BT11-011a ITB11-032a May 17, 2011

G37 CONVERTIBLE; HEADLINING CATCHING ON RETRACTABLE HARDTOP HINGE PIN

This bulletin has been amended. PARTS INFORMATION has been amended. Please discard previous copies.

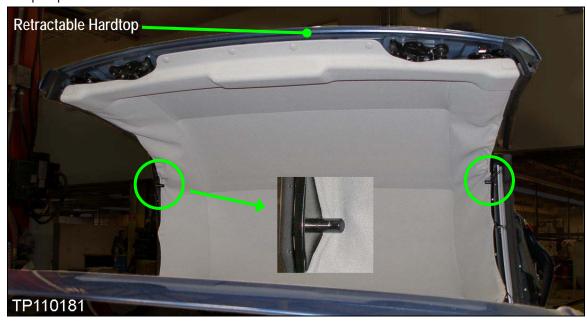
When closing the RHT (Retractable Hardtop), the headlining catches on one or both hinge pins (see below).

Replace <u>both</u> main tether cords listed in **PARTS INFORMATION** on Page 2.

- If the headlining is found damaged due to this incident, if it should occur, replace it.
- For main tether cord and headlining removal and installation, refer to the K>BODY EXTERIOR, DOORS, ROOF & VEHICLE SECURITY>RF>ROOF section of the Electronic Service Manual (ESM), if needed.
- See Page 2 for additional information. This information must be applied in addition to the ESM repair procedure.
